Addendum #1

Project Name: Cattle National Bank & Trust - Fallbrook
6550 Merchant Drive
Project No.: 12054
Issued: May 01, 2013
Bid Date: 2:00 pm, CDT May 14, 2013

Revision to Detail: A1/A100

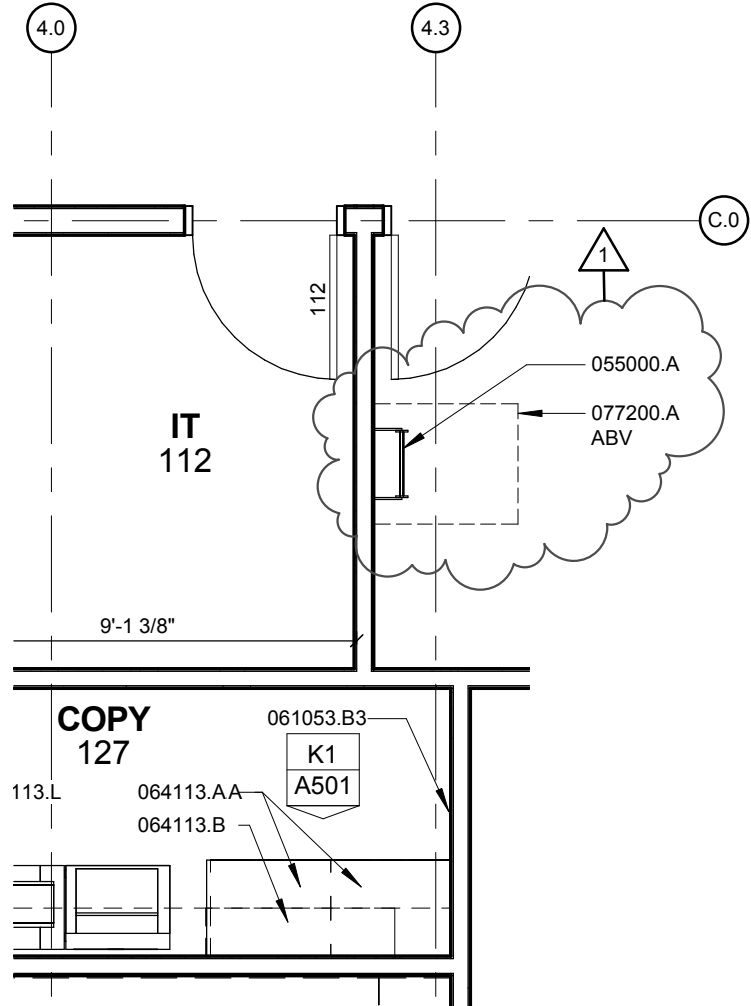
- a. A1/A100: Graphic update to the concrete islands at the teller drive to coordinate with Civil. Refer to Attachment A01.
- b. A1/A100: Changed dimension between the column and ATM to 1'-10 ¾”. Refer to Attachment A01.
- c. A1/A100: Added dimension of 5 inches to locate the Pneumatic Tube from the curb edge of the concrete island. Refer to Attachment A01.
- d. A1/A100: Changed Grid Line 4.8 to 4.7 and added Grid Lines 4.8 and 4.9 to coordinate with Structural. Dimension string was modified accordingly. This modification is typical throughout the architectural sheets. Refer to Attachment A01.

Revision to Detail **A4/A110 & KEYNOTES**

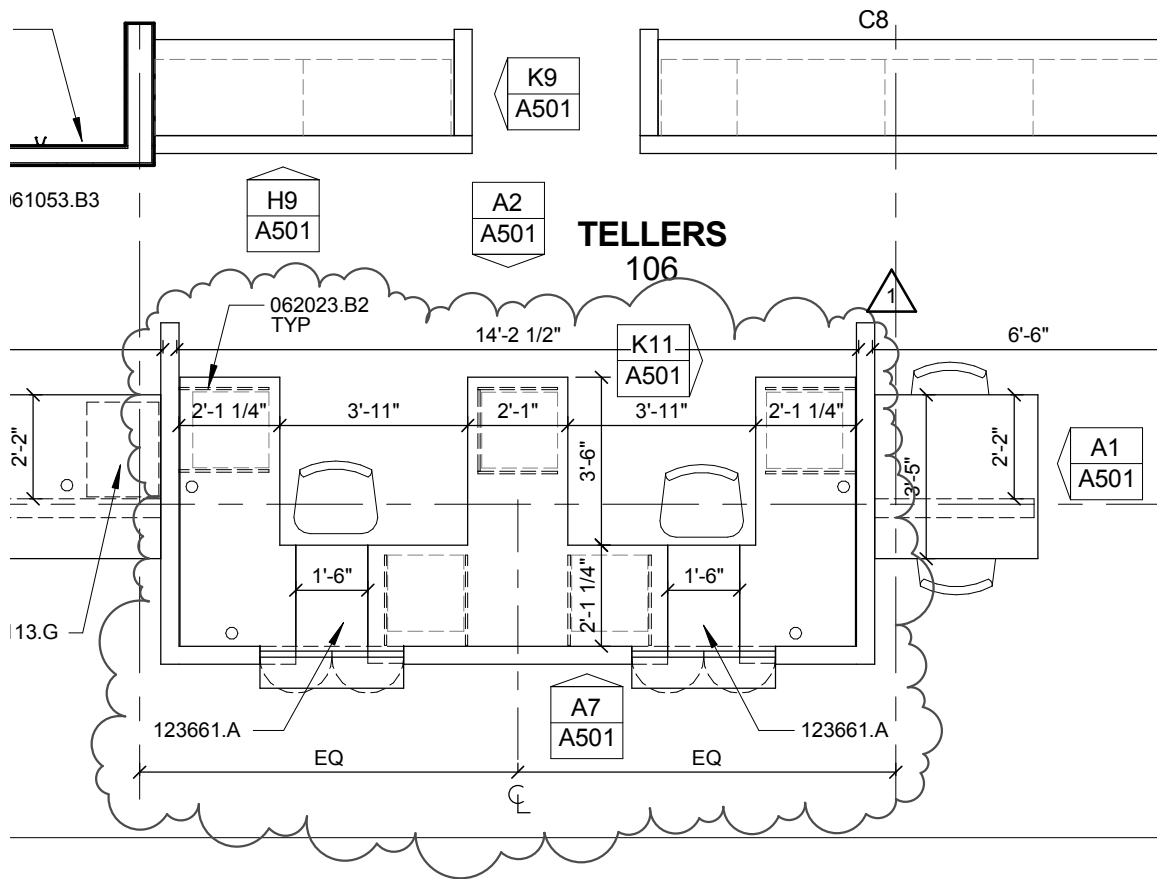
- a. A4/A110: Added access ladder to roof hatch in Mech/Elec 113. Refer to Attachment A02.
- b. E4/A110: Added support legs to teller station dashed in below countertop. Added dimensions and graphically updated teller doors. Added under counter steel cabinetry to middle teller counter. Added interior elevation tag. Refer to Attachment A03.

Revision to Detail **E1/A200**

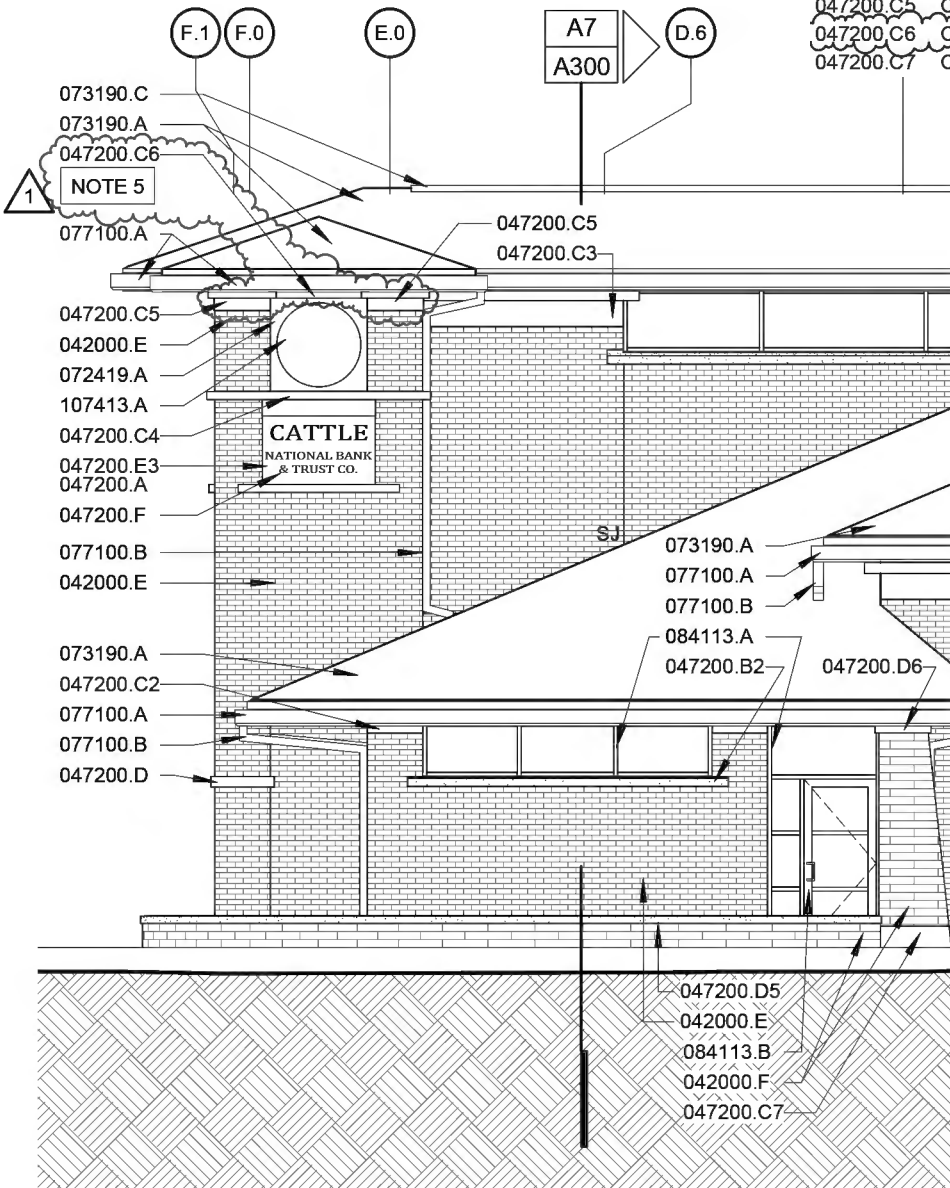
- a. E1/A200: Graphic modification to Cast Stone Belt Course – Style 5 (047200.C5) to show profile returning at EIFS. Refer to Attachment A04.
- b. E1/A200: Added Keynote 047200.C6 “Cast Stone Belt Course – Style 6” to cast stone at EIFS above the clock. Refer to Attachment A04.
- c. E1/A200: Added Sheet Specific Note 5 to cast stone at EIFS above the clock. Sheet Specific Note 5 reads “Precast to be self-supporting. Connect to the cast stone on either side or notch the abutting precast (047200.C5) to allow precast to bear.” Refer to Attachment A04.

Revision to Detail: E1/A201

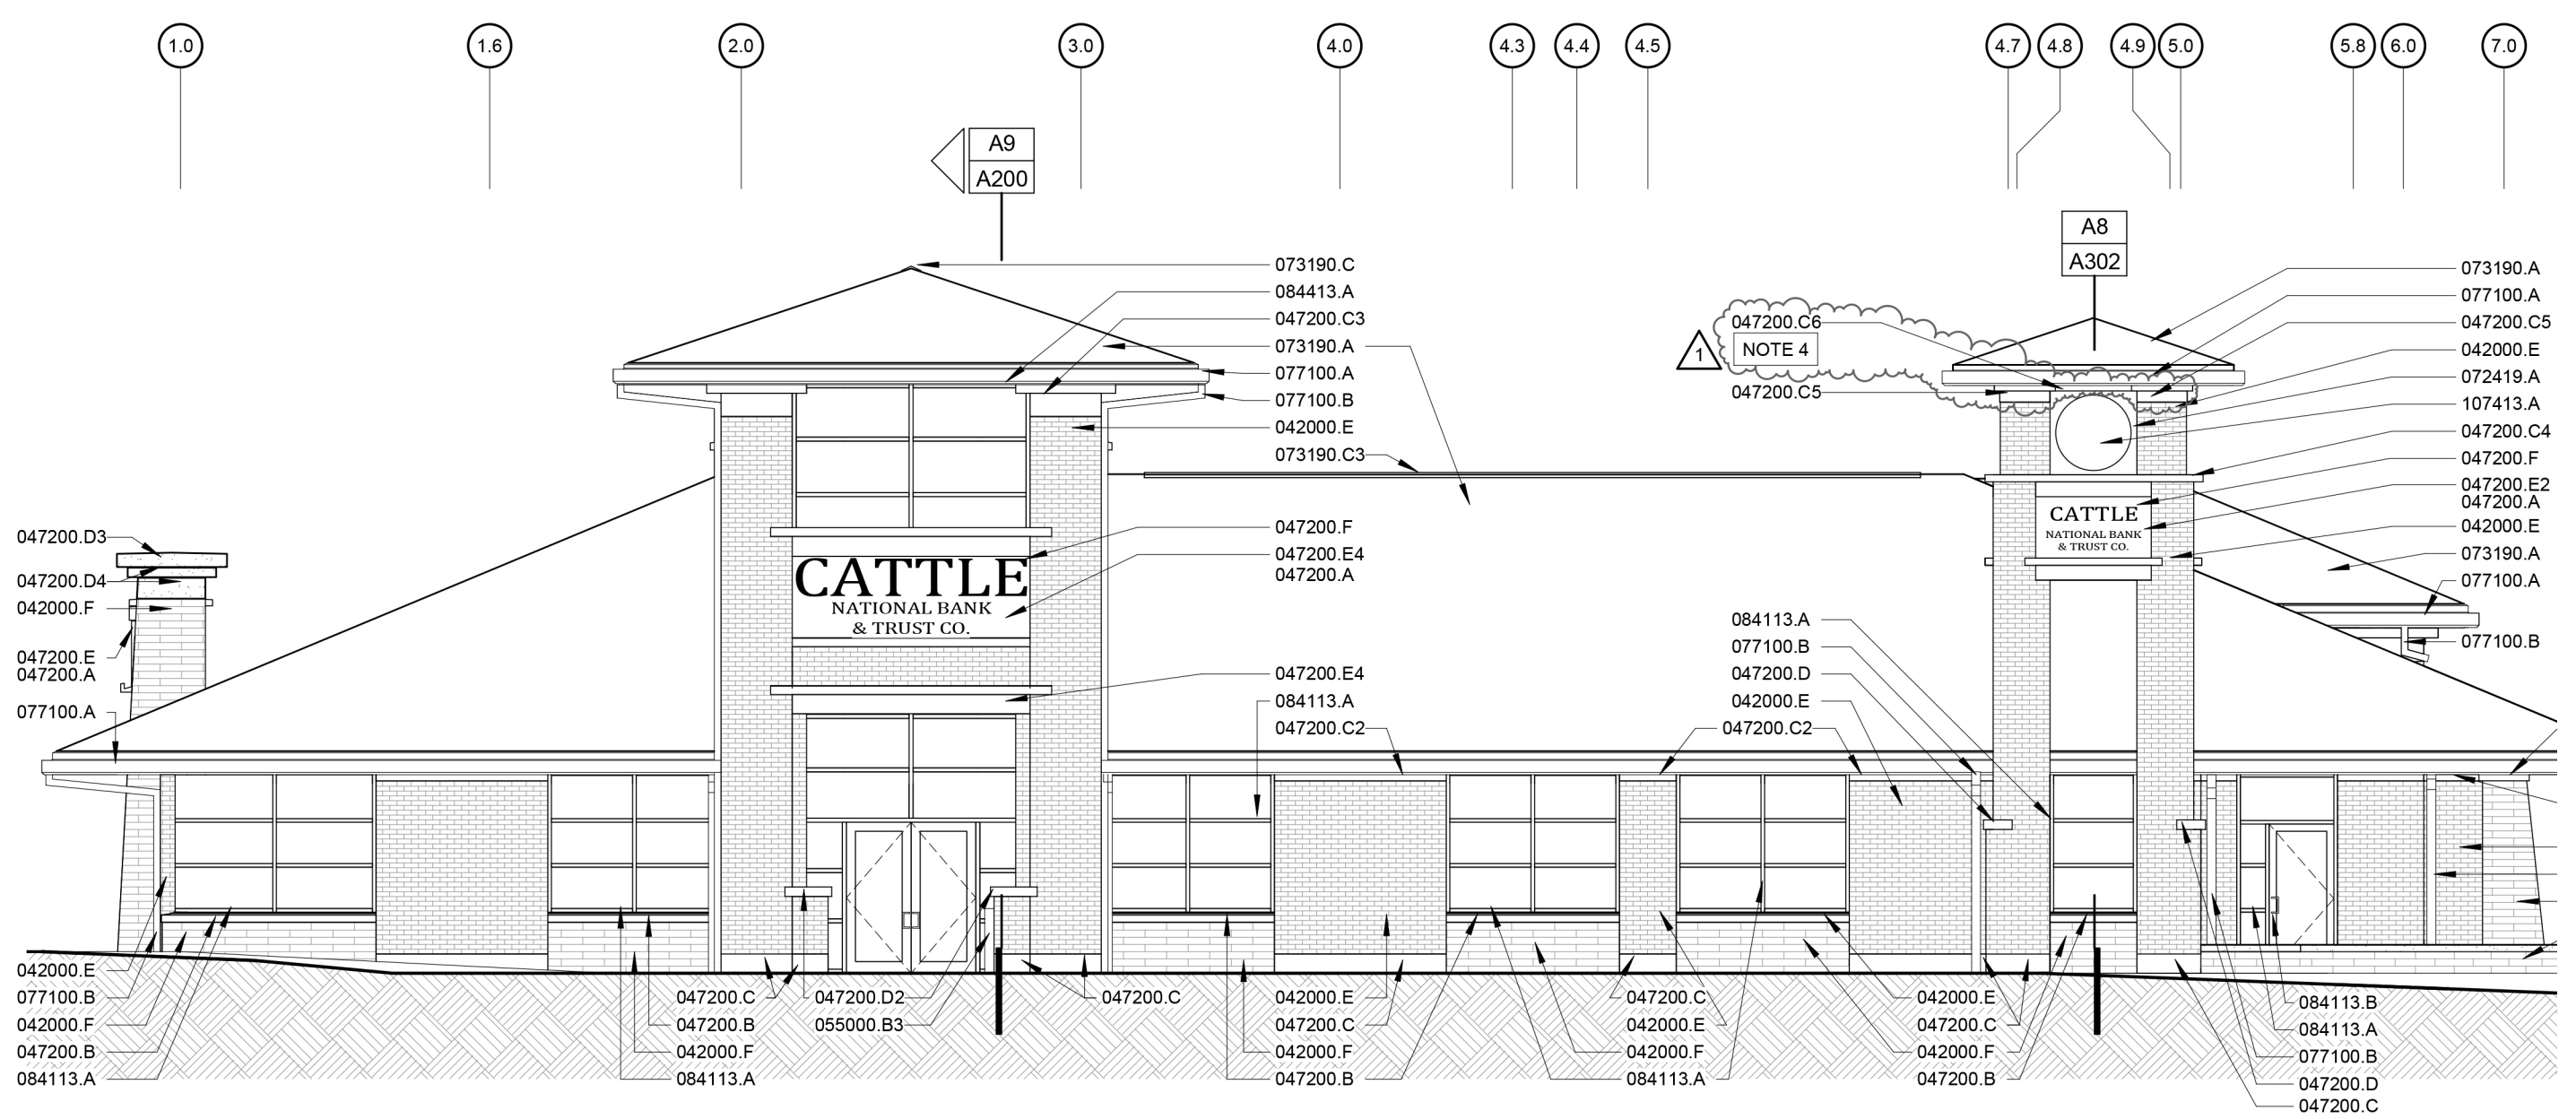
- a. J1/A201, E1/A201, and E10/A201: Graphic modification to Cast Stone Belt Course – Style 5 (047200.C5) to show profile returning at EIFS. Refer to Attachment A05, A06 & A07.
- b. J1/A201, E1/A201, and E10/A201: Added Keynote 047200.C6 “Cast Stone Belt Course – Style 6” to cast stone at EIFS above the clock. Refer to Attachment A05, A06 & A07.
- c. J1/A201, E1/A201, and E10/A201: Added Sheet Specific Note 4 to cast stone at EIFS above the clock. Sheet Specific Note 4 reads “Precast to be self-supporting. Connect to the cast stone on either side or notch the abutting precast (047200.C5) to allow precast to bear.” Refer to Attachment A05, A06 & A07.
- d. J1/A201: Added Cast Stone Sill Style 4 at Teller Window. Refer to Attachment A05, A06 & A07.
- e. J1/A201: Added Keynote 047200.B4 “Cast Stone Sill – Style 4” to Teller Window Sill. Refer to Attachment A05, A06 & A07.

Revision to Detail **A4/A300**

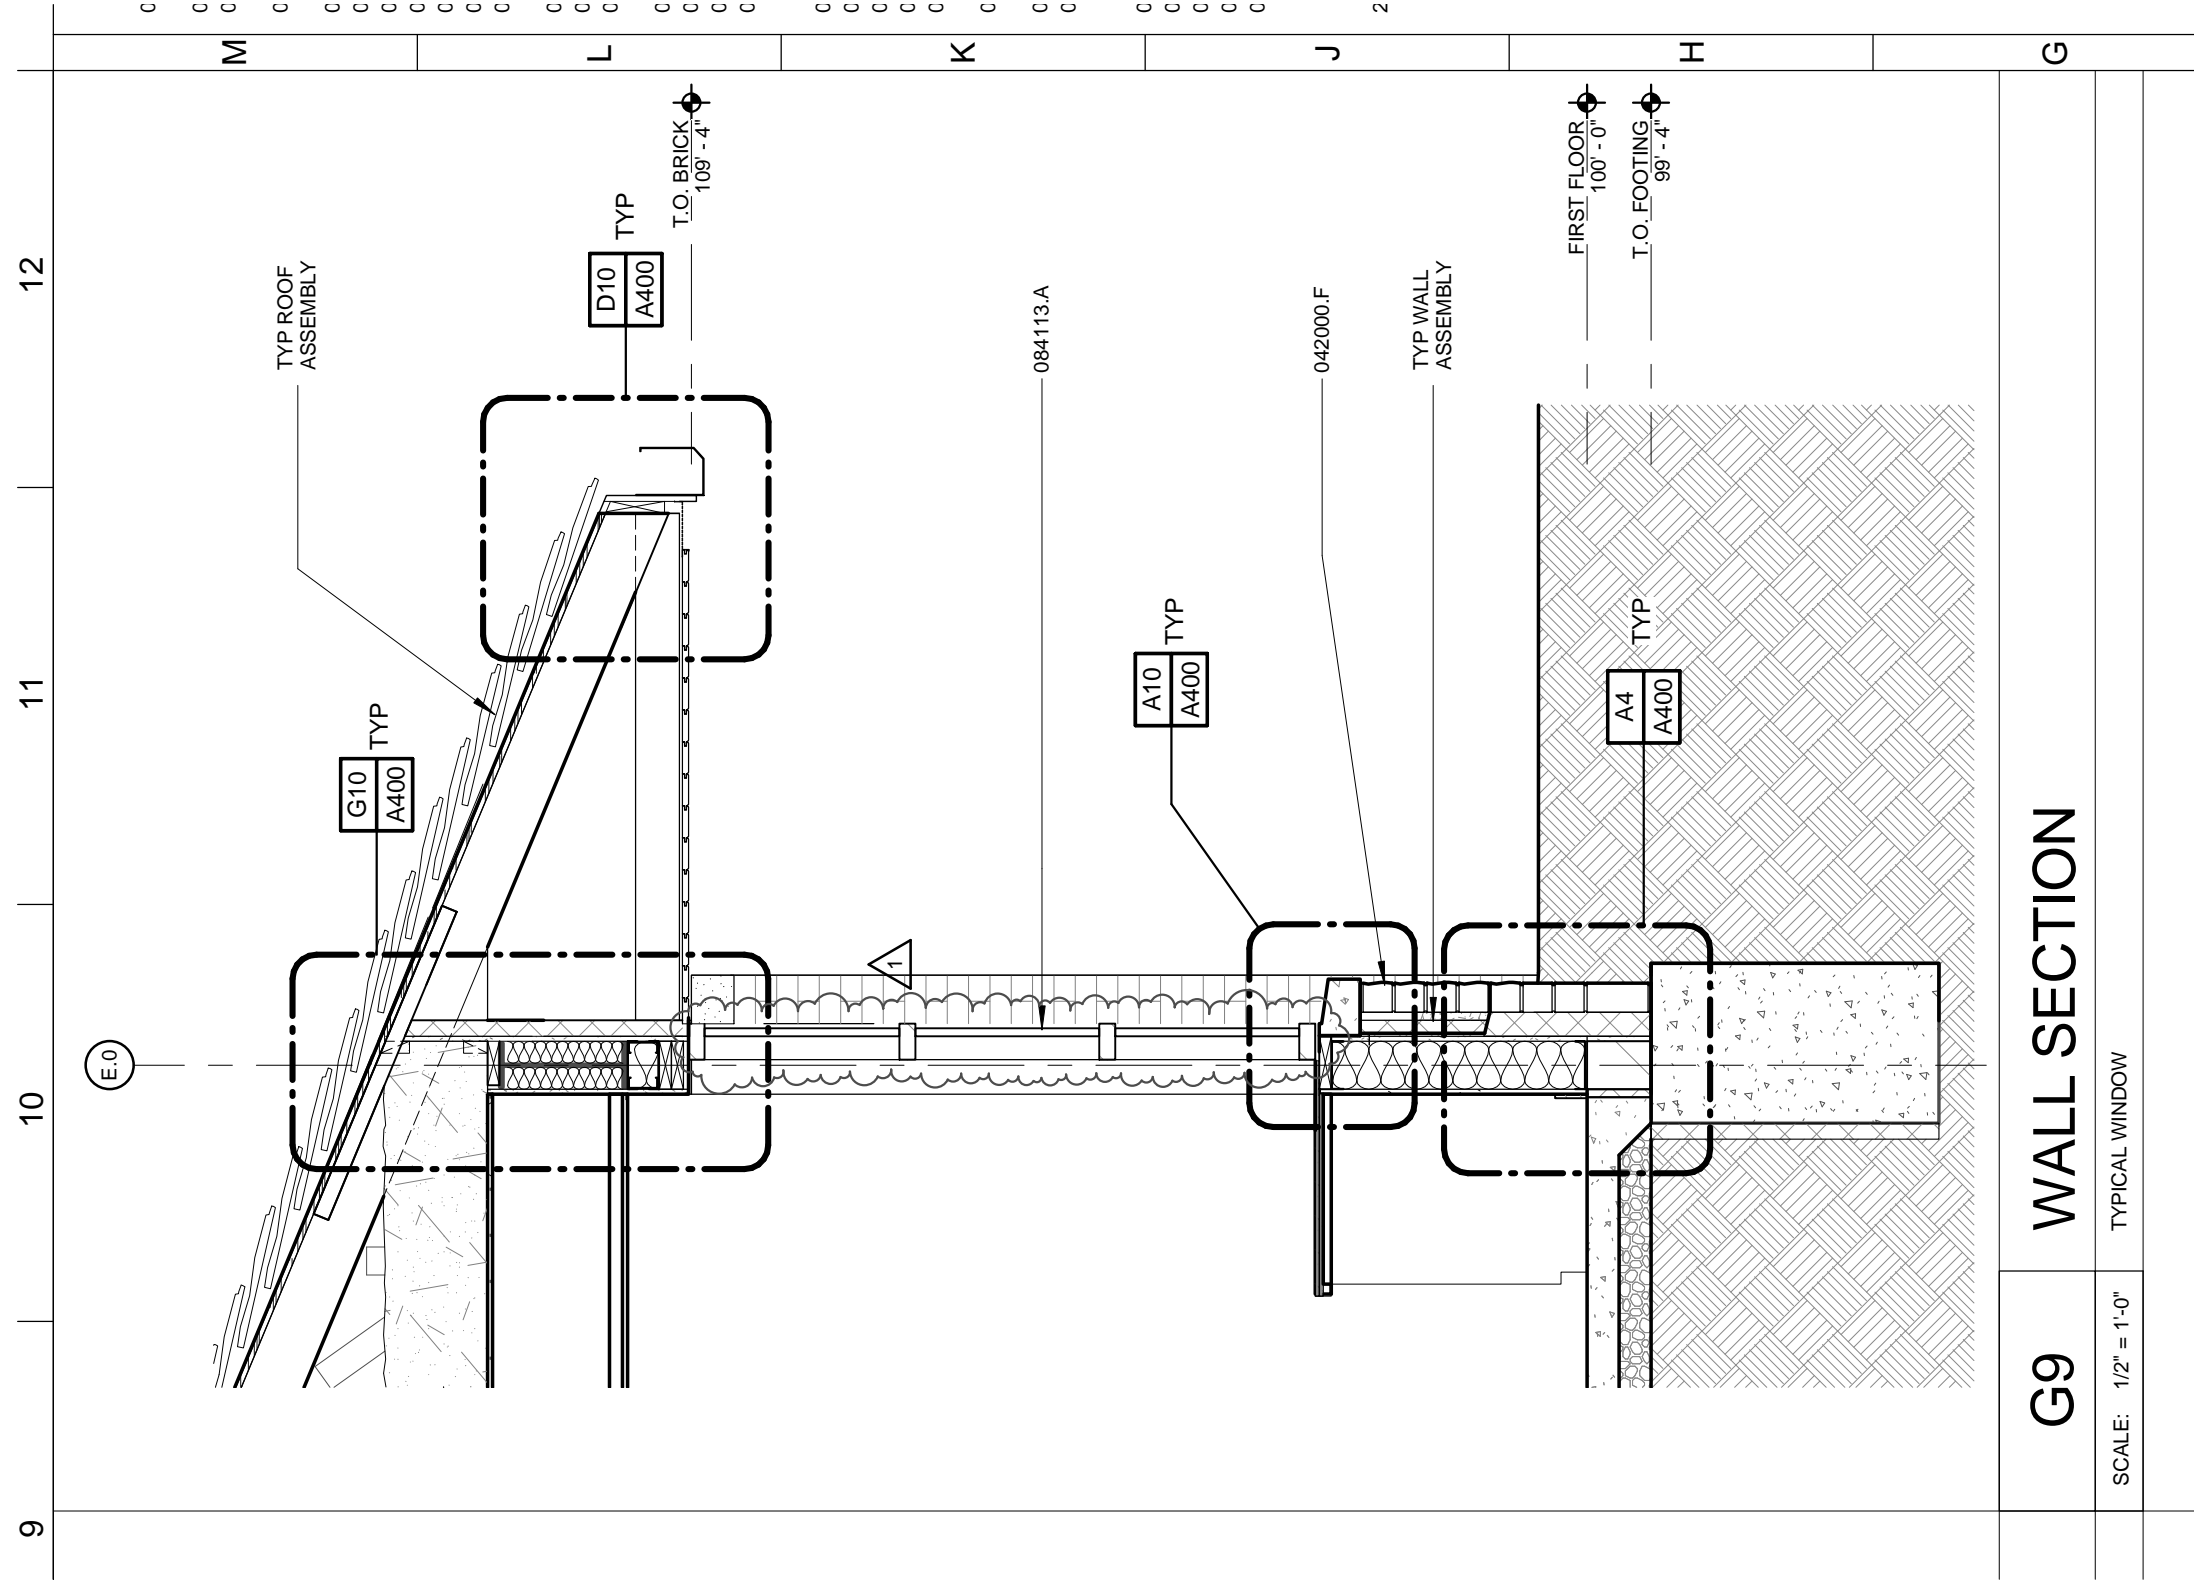
- a. A4/A300: Moved up Thru-wall Flashing Assembly, 2-Piece Counterflashing, and Termination Bar one brick coursing to coordinate with A10/A402 and Structural. Refer to Attachment A08.
- b. G9/A300: Graphically coordinated window location in section with details. Refer to Attachment A09.
- c. G4/A300: Graphically updated 3" spray foam insulation to coordinate with D4/A401 and changed dimension from finish floor to bottom of counter to be 3'-2 ½". Refer to Attachment A10.
